BMC MINERALS (NO.1) LTD

KUDZ ZE KAYAH PROJECT

RESPONSE TO YESAB EXECUTIVE COMMITTEE ADEQUACY REVIEW OF KZK

July 2017

TITLE: Simulated Permafrost			
LOCATION: Kudz Ze Kayah Project, Yukon, CA			
	APPROVED	CKG	FIGURE 9-1
	DRAFTED	CKG	
	PROJECT#	EBA-KZK	
	DATE	09-28-16

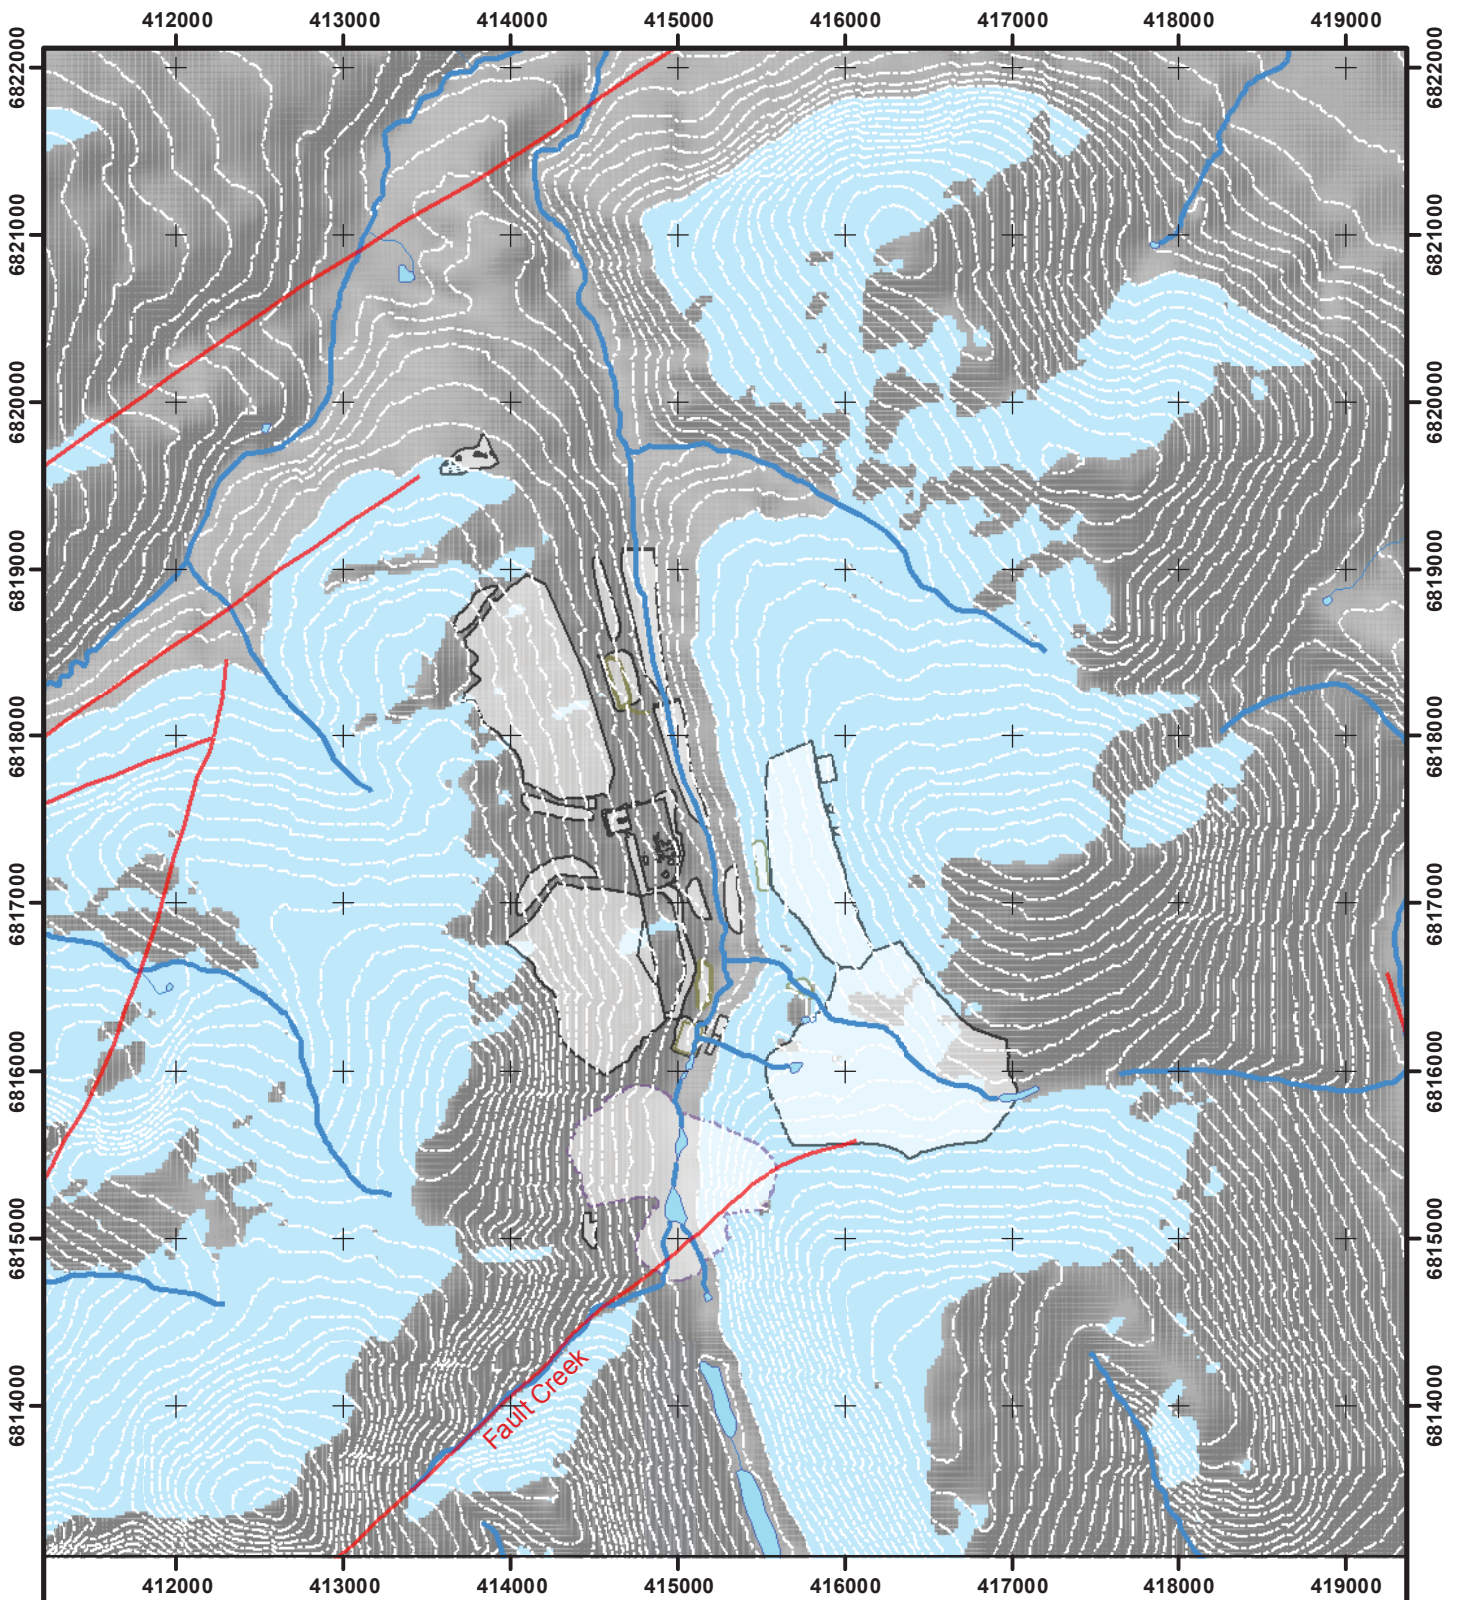
The Proponent has indicated that discontinuous permafrost to exist in the project area. "The Project is located in an area with discontinuous permafrost. Norecol, Dames & Moore Ltd. (1996) noted that permafrost is present on north and west facing slopes along the Geona Creek valley, especially above 1,400 masl."

Despite the Proponent's conclusion, ECCC notes that groundwater permafrost interaction is an important component of project impact assessments and water license process. Potential groundwater-surface water interactions at the valley aquifer and Geona Creek can likely be influenced by the presence or absence of permafrost conditions slopes where groundwater recharge occurs. For ECCC to assess impacts to quality and quantity of groundwater and surface water, the groundwater-permafrost interactions need to be adequately characterized. As such, the potential impact of dewatering (overburden, bedrock) to quality and quantity of groundwater, Geona Creek, South Creek, Finlayson Creek and other surface water cannot be assessed based on the insufficient information with respect to nature of the permafrost. The Water license process requires the Proponent to determine whether there is a likely hydraulic connectivity between groundwater aquifers and permafrost.

TITLE:			
Post-Closure Waste Rock Particle Tracking			
LOCATION:			
Kudz Ze Kayah, Yukon, CA			
 TETRA TECH	APPROVED	CKG	FIGURE 9-3
	DRAFTED	CKG	
	PROJECT#	GWTR03021	
	DATE	11-04-2016

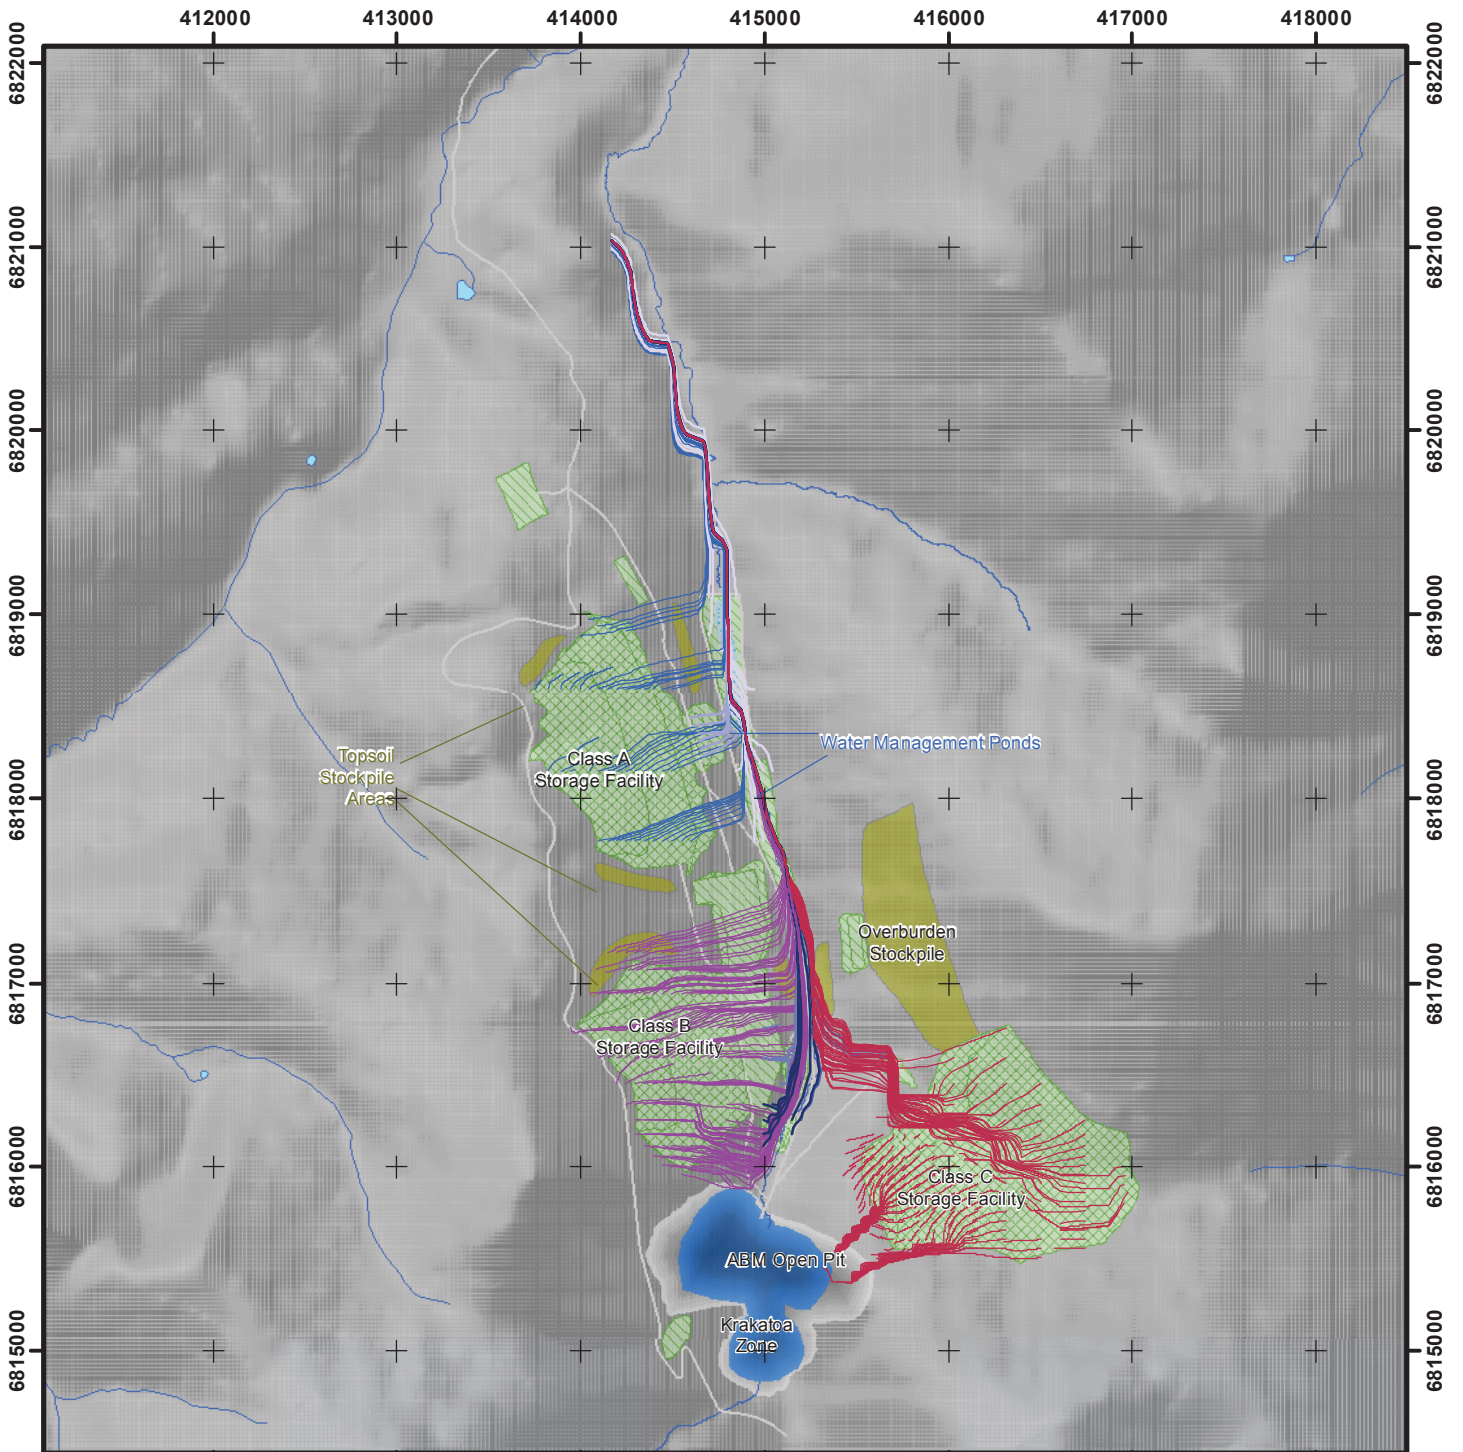
The surficial geology below the Class A waste rock facility suggests variable ground conditions, comprised of morainal tills, glaciofluvial complex and fan deposits. Further, the glaciofluvial deposits constitute the “downstream” toe of the S-PAG dump; extending in direction to downgradient of the potential capture influence of the lower-most water management pond (Figure 3).

ECCC notes that there are no monitoring wells installed in the vicinity of Class A Storage Facility to assess the potential impact of infiltration out of the facility on the receiving environment. In addition, there has been insufficient information with respect to the potential capture of infiltration out of the Class A Storage Facility.

Further, ECCC notes that the saturated screen lengths used to monitor groundwater quality didn't comply with standard procedures and recommendations as provided in BC MOE 2009b. As recommended by BC MOE, maximum saturated screen lengths should be limited to 1.8 m within the target hydrostratigraphic unit. The use of longer screens for water quality monitoring would cause dilution of constituents and water quality data from such wells should not be compared directly with groundwater quality standards unless supporting rationale can be provided.

**FIGURE 13-2
BIRD SITE SURVEY LOCATIONS
2015-2016**

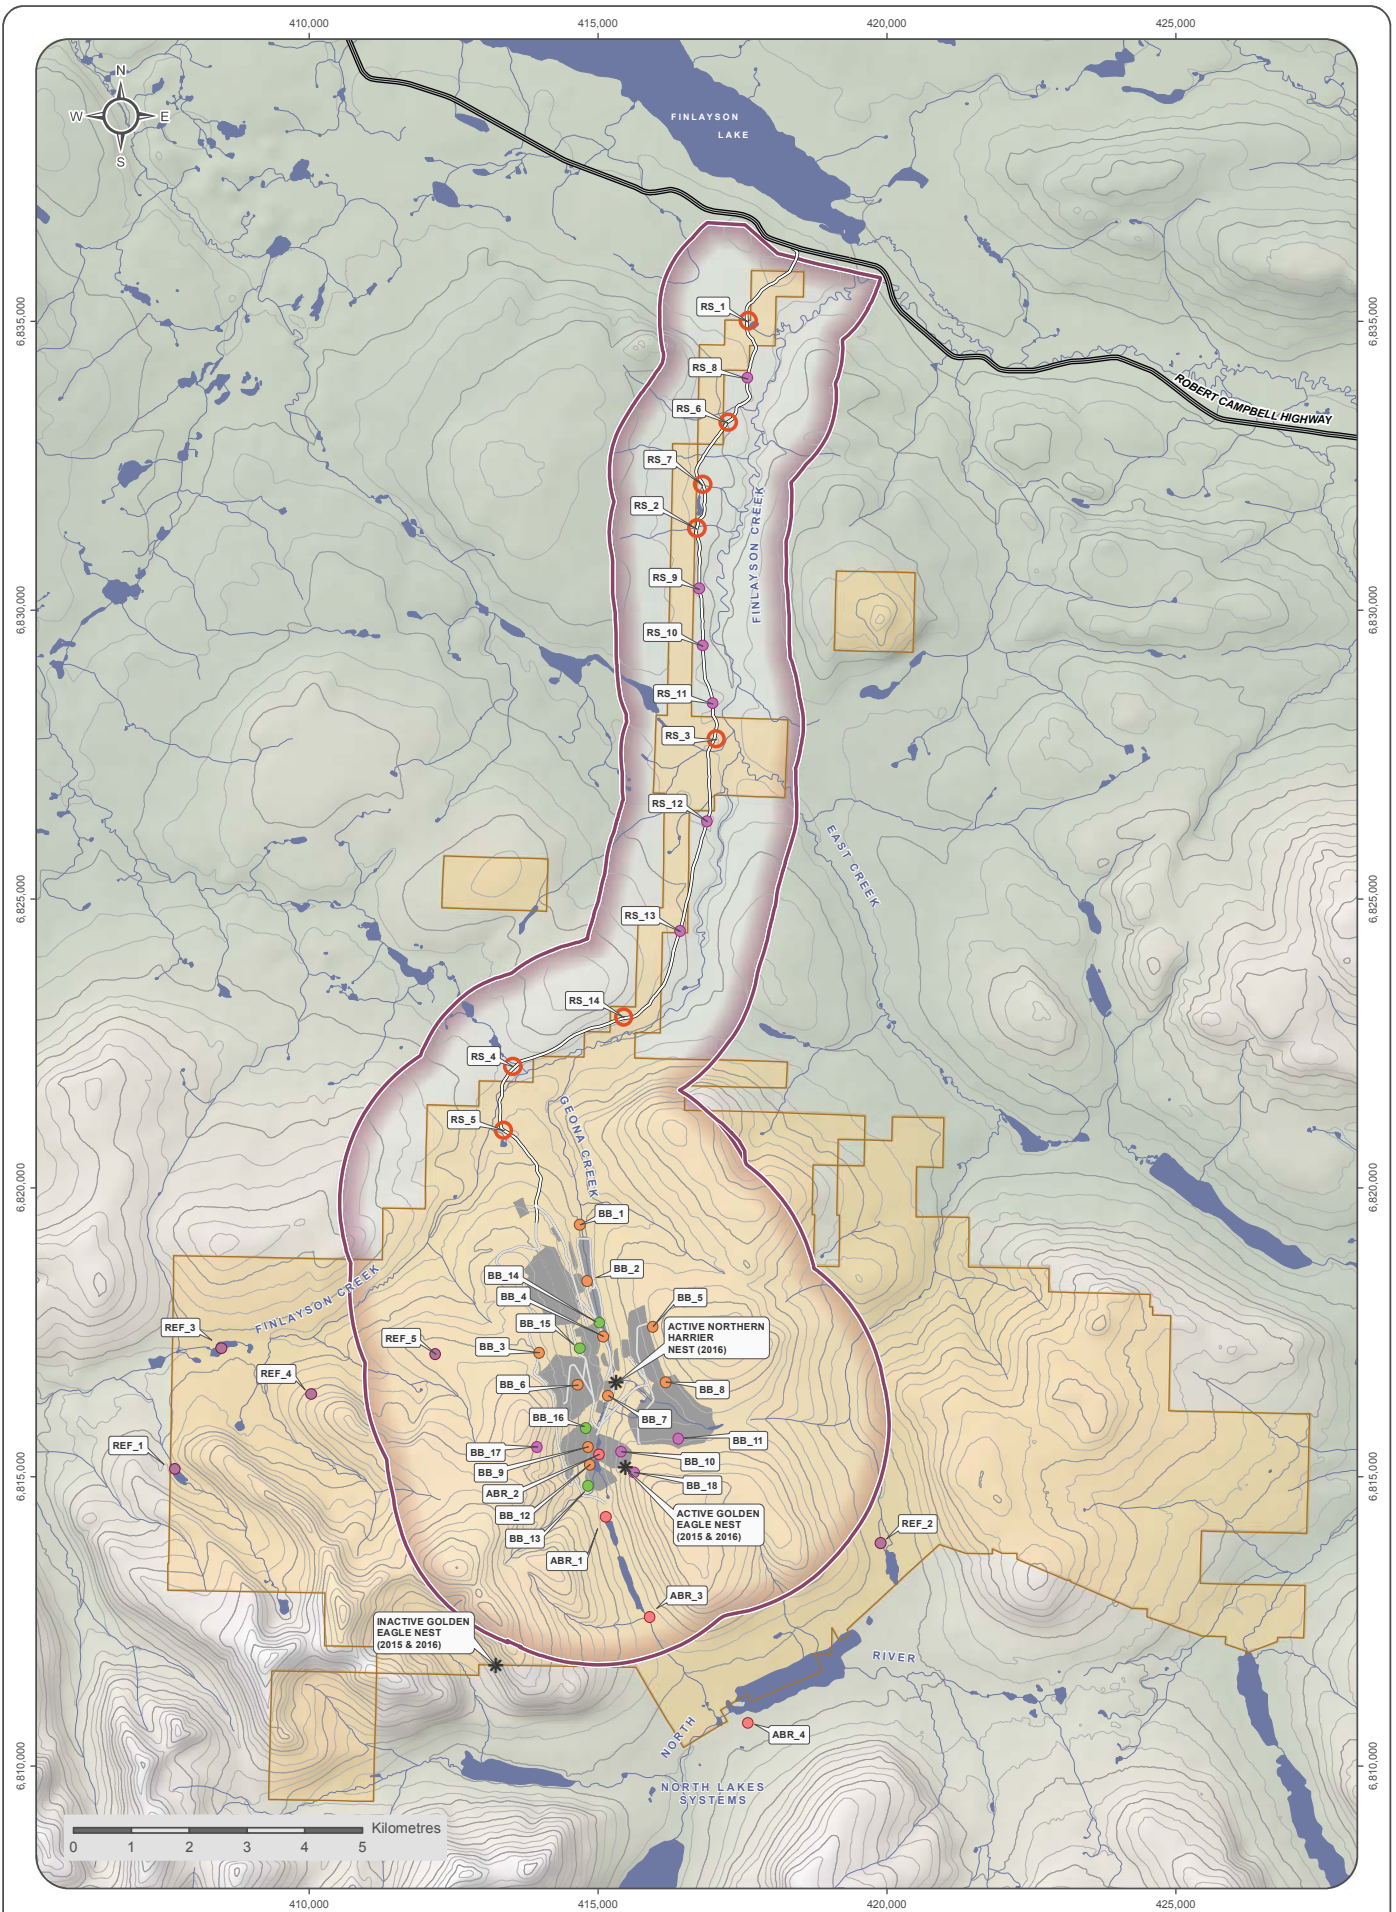
“Clarify the inconsistencies in the sections on passerine surveys (refer to the list of examples, above). Are survey data for 2016 available?”

BMC recognizes that there were a number of inconsistencies that occurred between the text and data. Figure 13-2 (below), Bird Survey Locations, has been updated from Figure 13-1 in the Wildlife Baseline Report, Appendix E-8 (to include all point count locations from the 2015 and 2016 surveys).

**FIGURE 13-3
FINLAYSON CARIBOU HERD
POST-CALVING OBSERVATIONS
2015-2016**

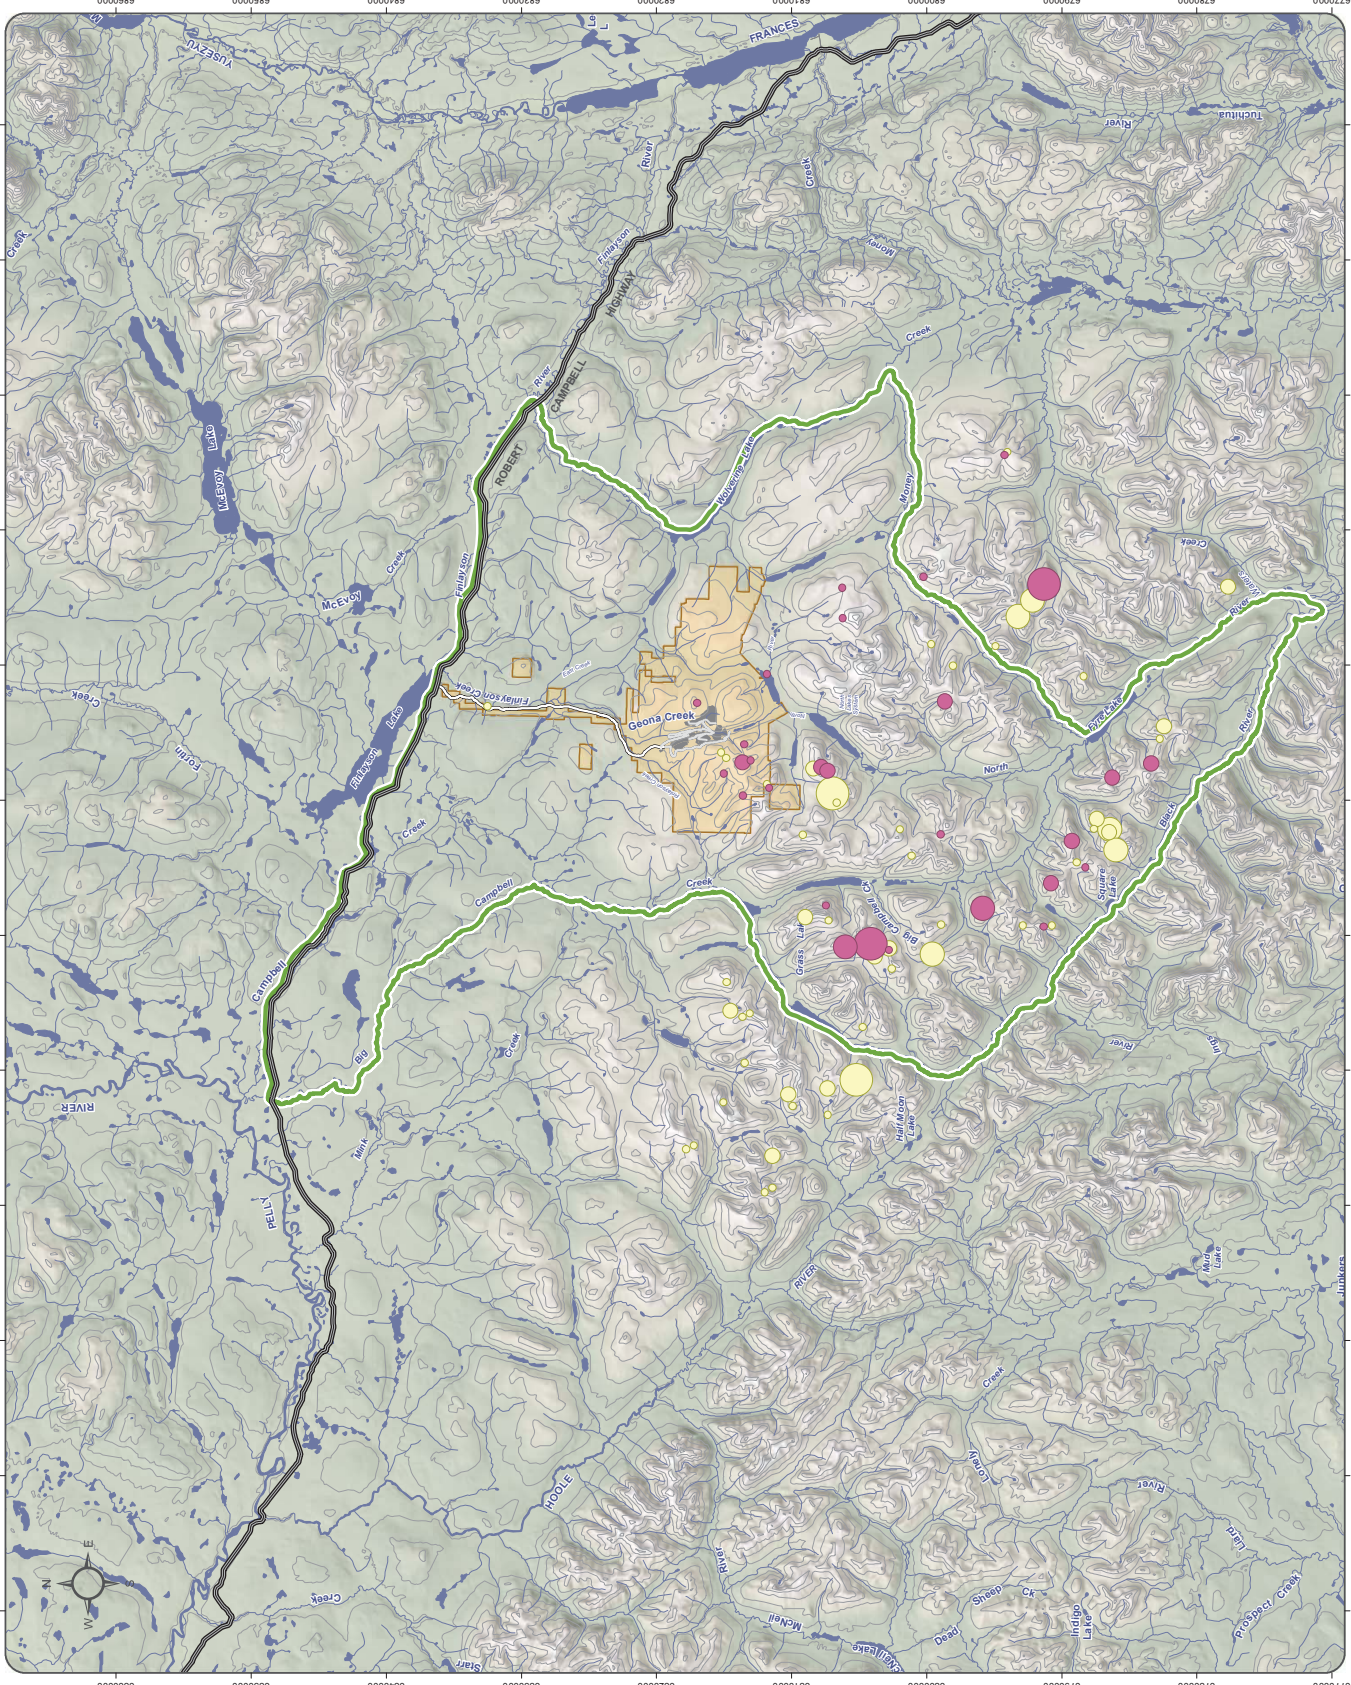
c. Improvement in post-calving information: Display locations for 2015 and 2016 in different colours on Figure 3-8 and comment on consistency in area use between the two years.

Figure 13-3 presents the corrected figure for Finlayson Caribou Herd, Post-calving Observations 2015-2016, from the Wildlife Baseline Report, Appendix E-8 of the Project Proposal and includes the 2016 observations in a different colour. Post-calving observations were distributed throughout the mountains south of the Project. There were more observations closer to the Project area in 2015 than in 2016 and the 2016 observations extended further to the west than in 2015.
